Addendum # 3 Coastal Resiliency and Living Shoreline Project

Date of Addendum: 9/13/22

NOTICE TO ALL BIDDERS AND PLANHOLDERS

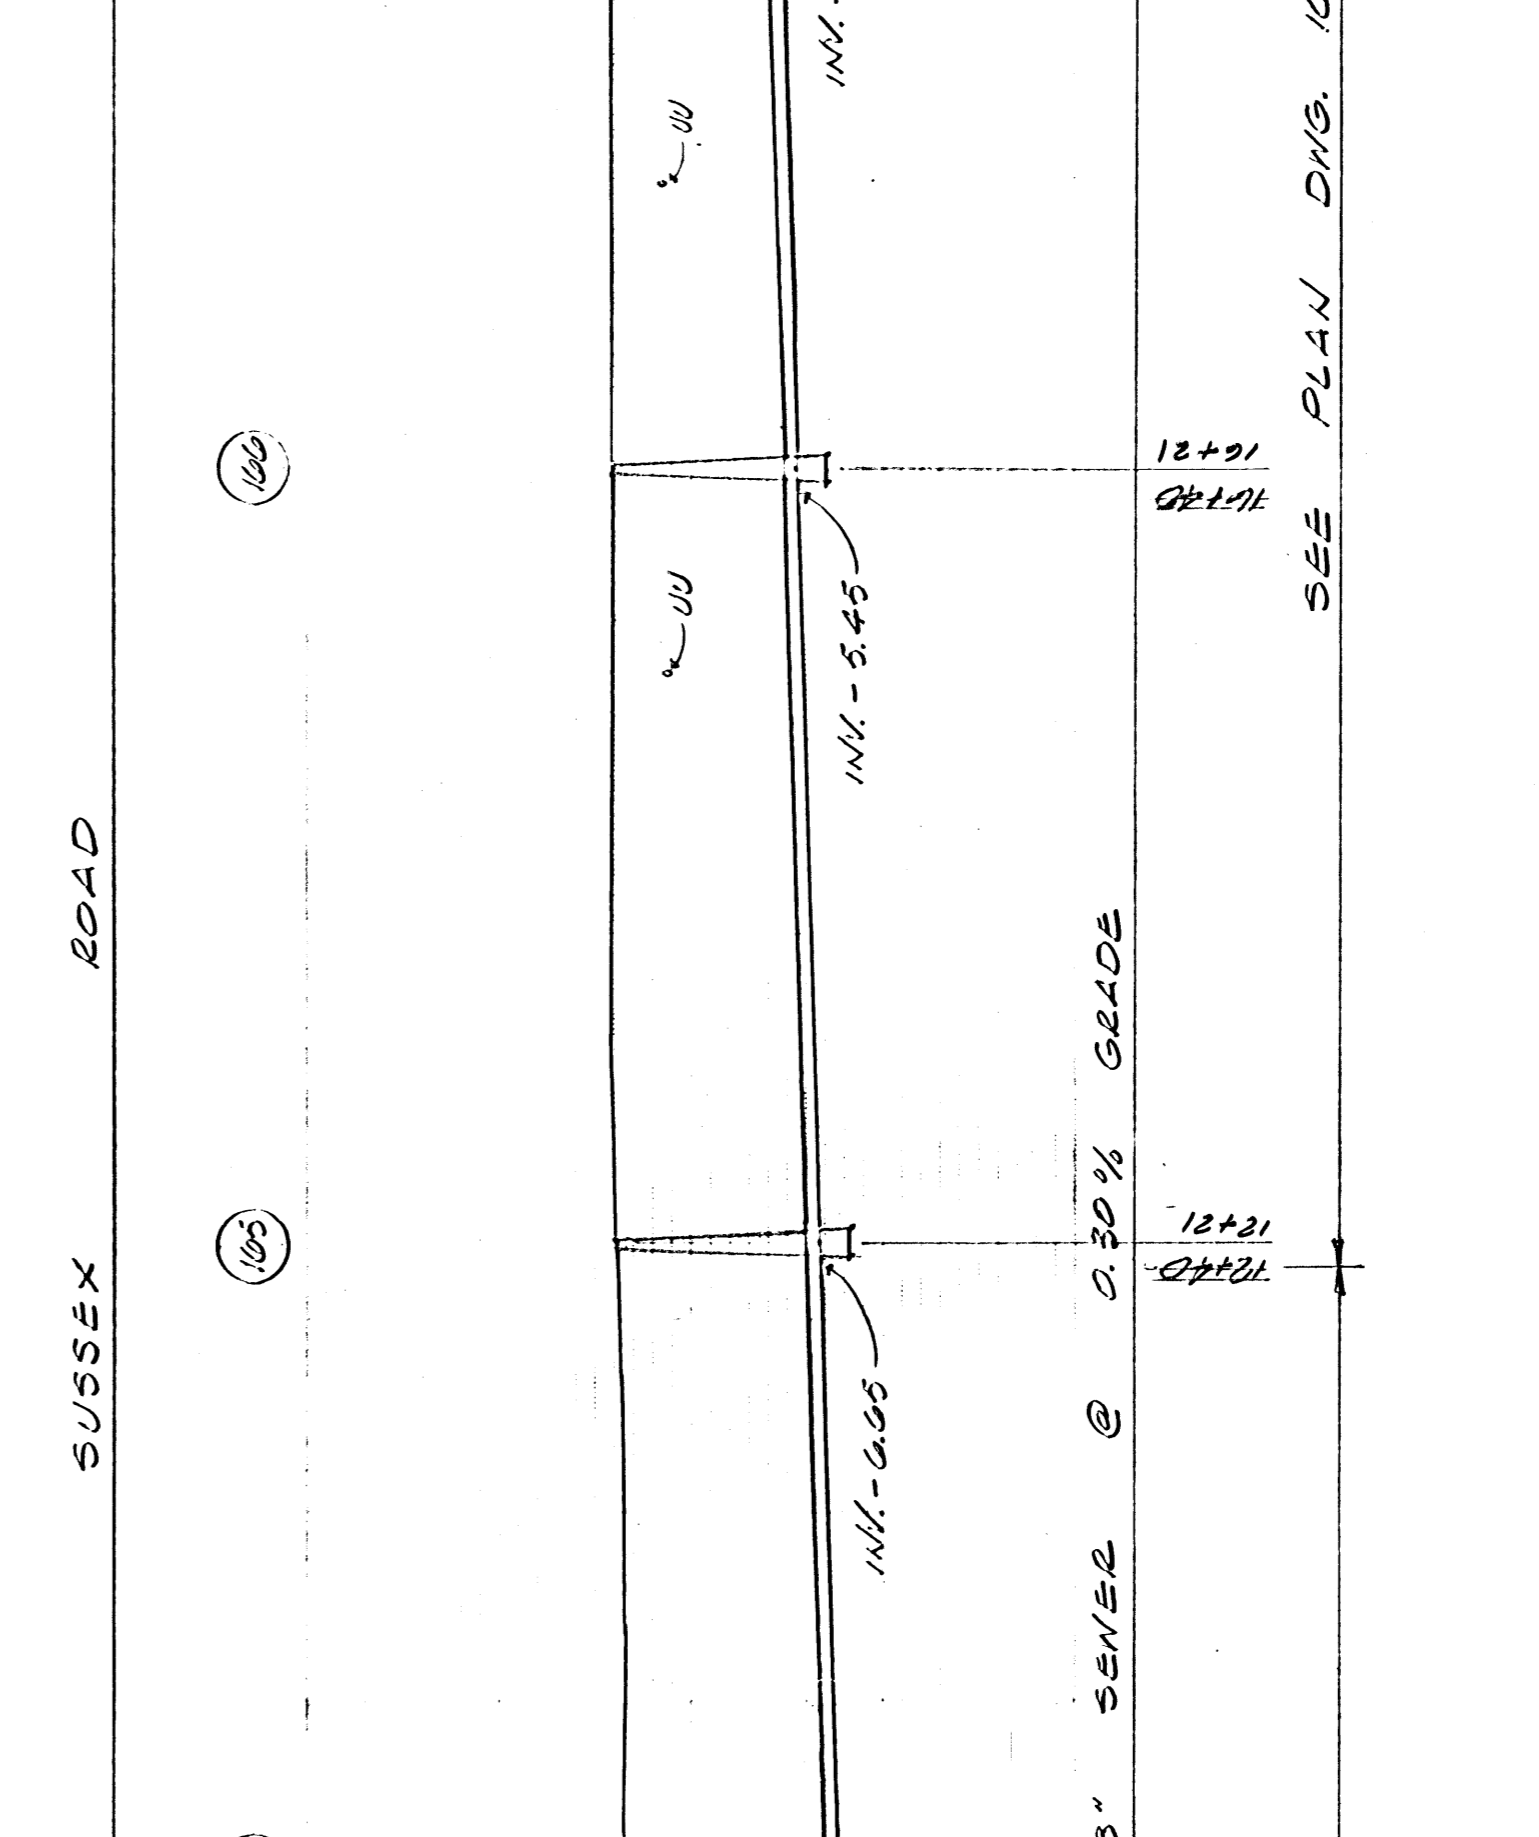
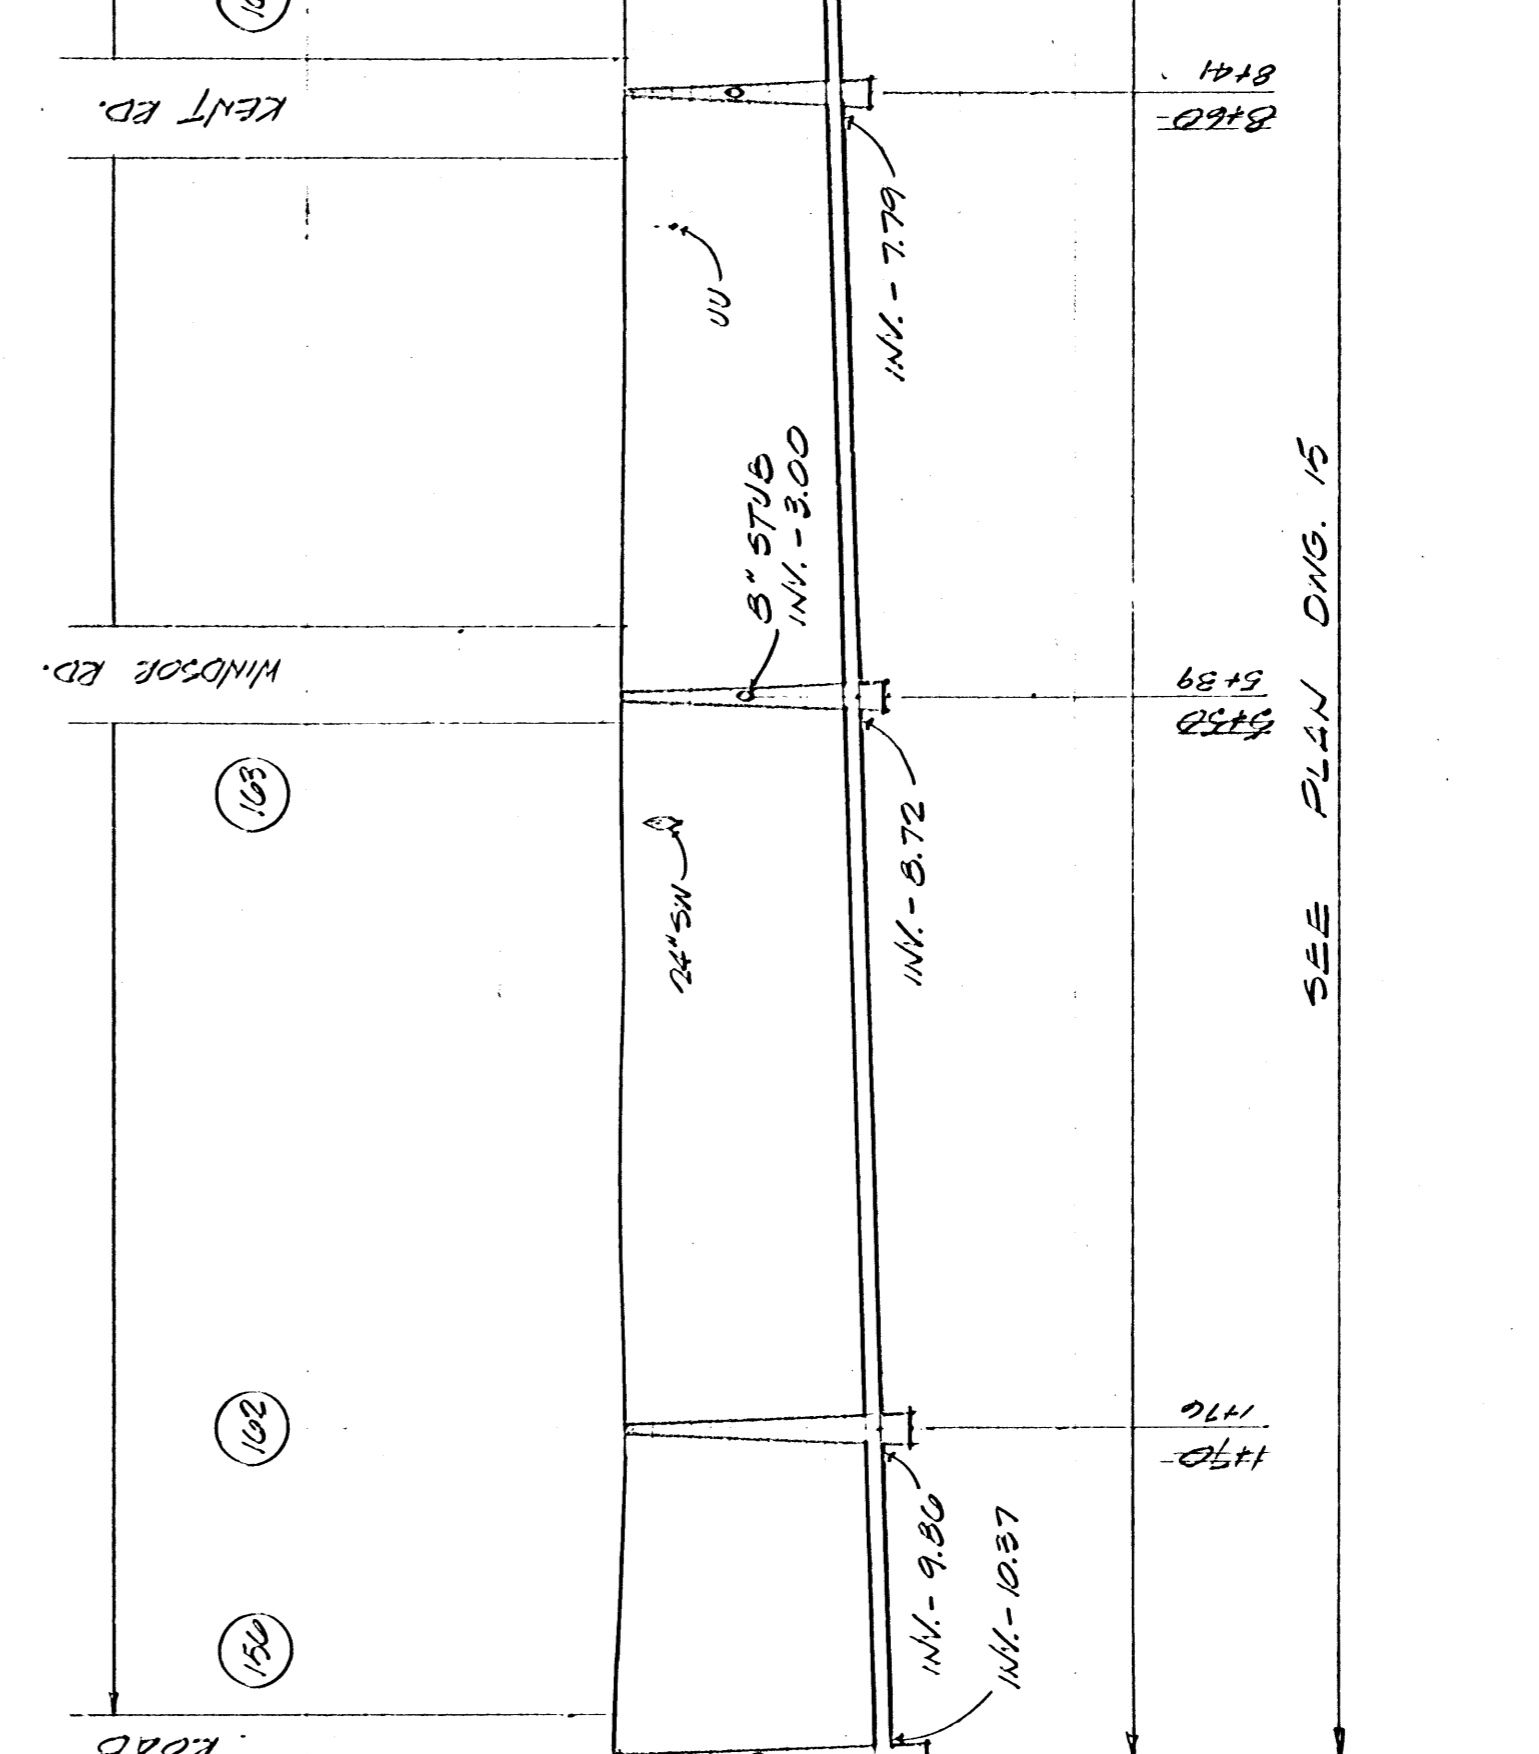
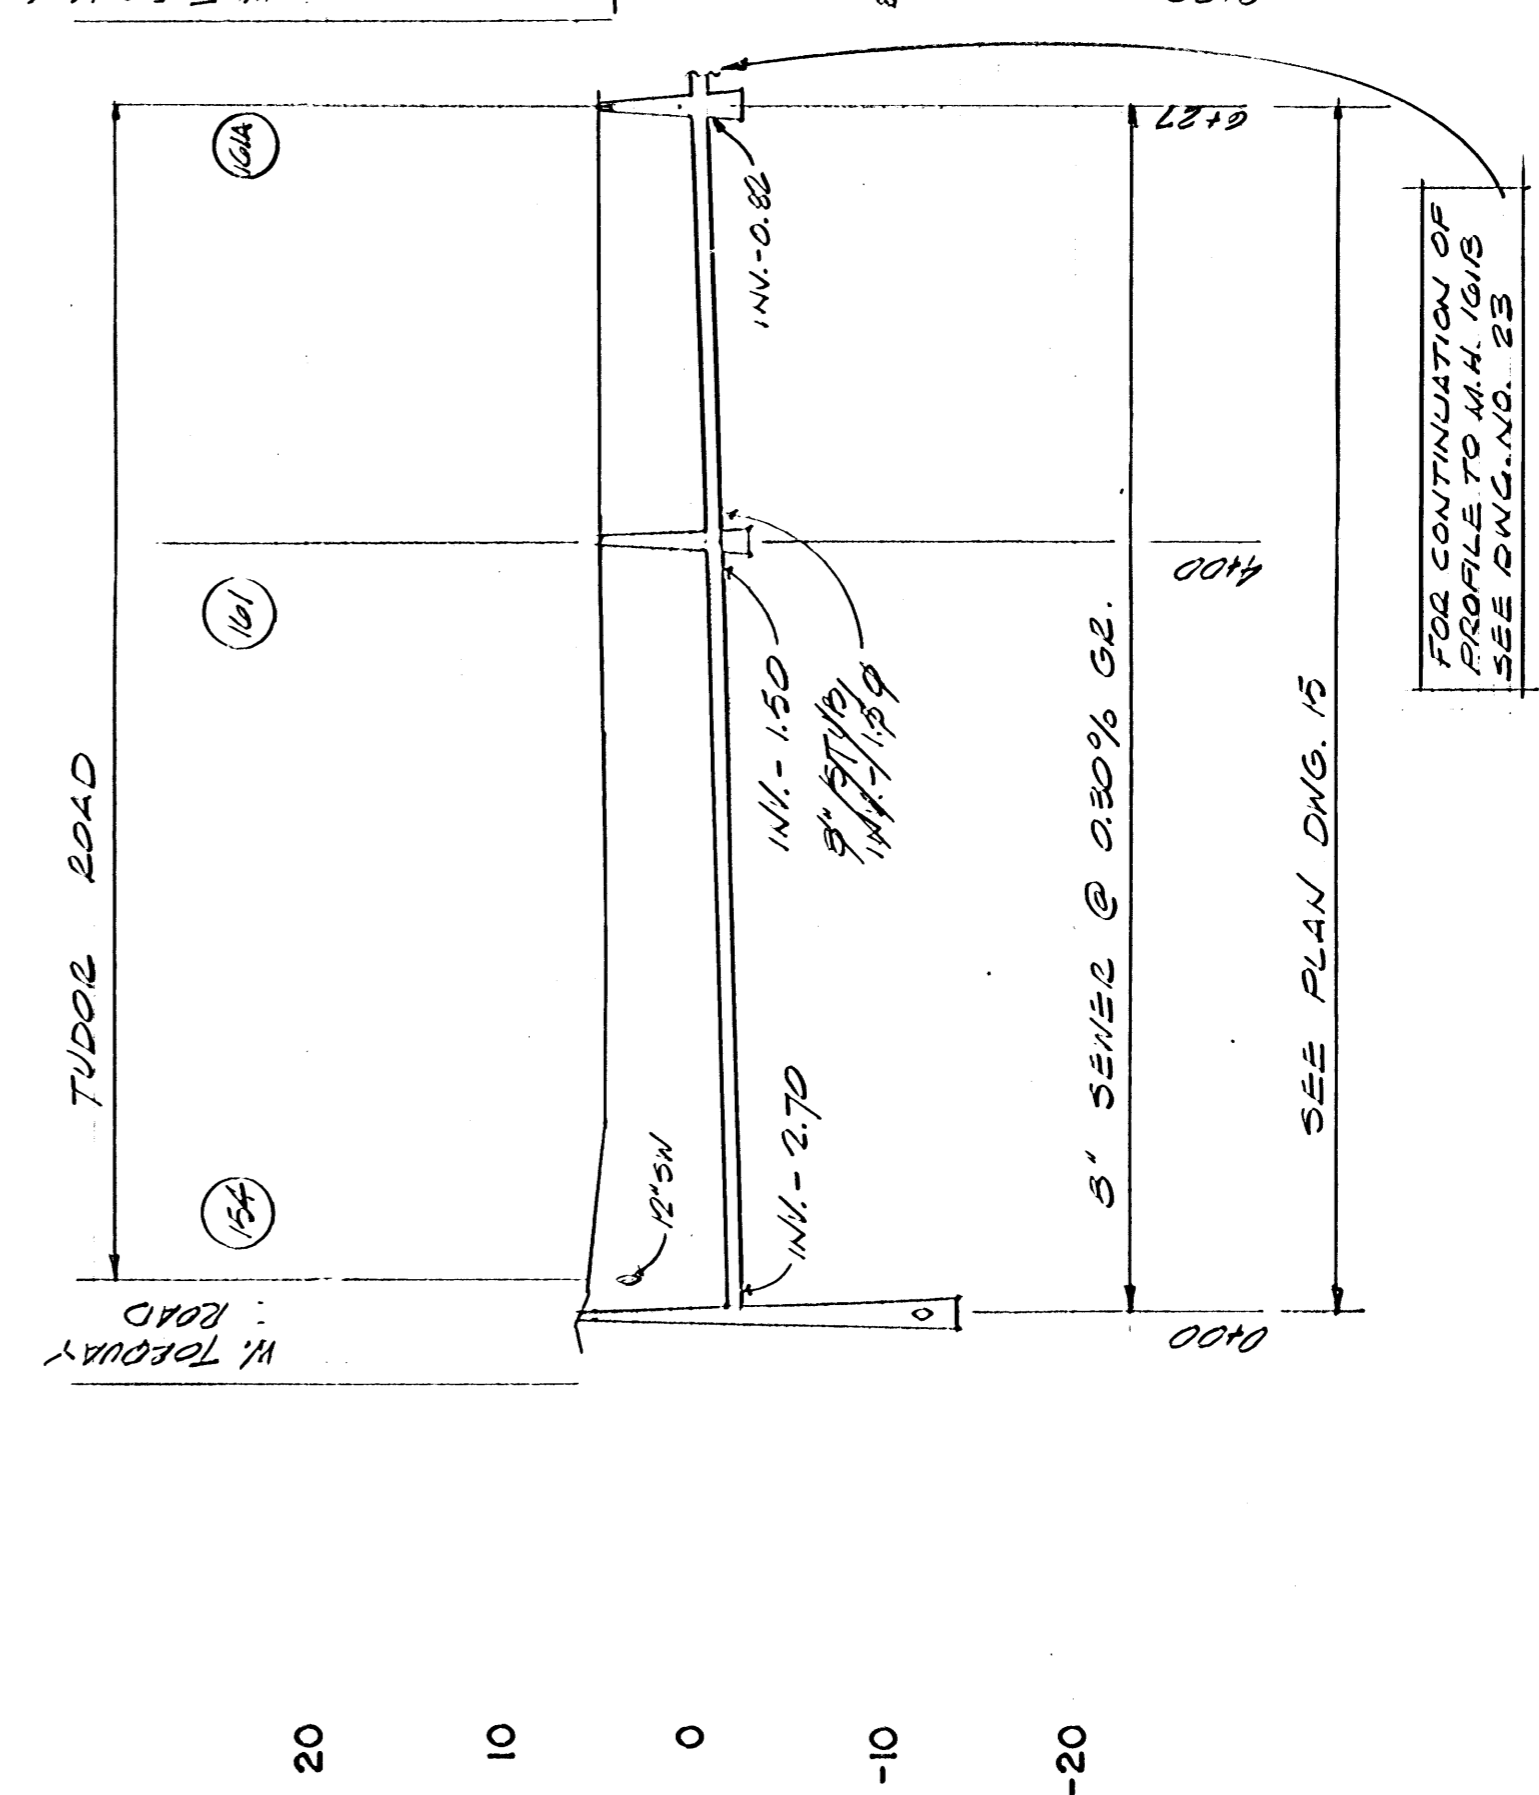
1.20	Q. Is there a survey of the sewer lines under the road? <i>A. Please see attached plans that illustrate location and profiles of sewer main.</i>
1.21	Q. Concerned about storm damage to the project ("act of God") and the responsibility of the contractor to repair damage during construction.

2.0 – ATTACHMENTS	
Item	Description
2.1	REVISED Construction Bid Form *This is to be used in lieu of the Construction Bid Form that was provided in the original Bid Documents.
2.2	Two files have been attached that illustrate location and profiles of sewer main.
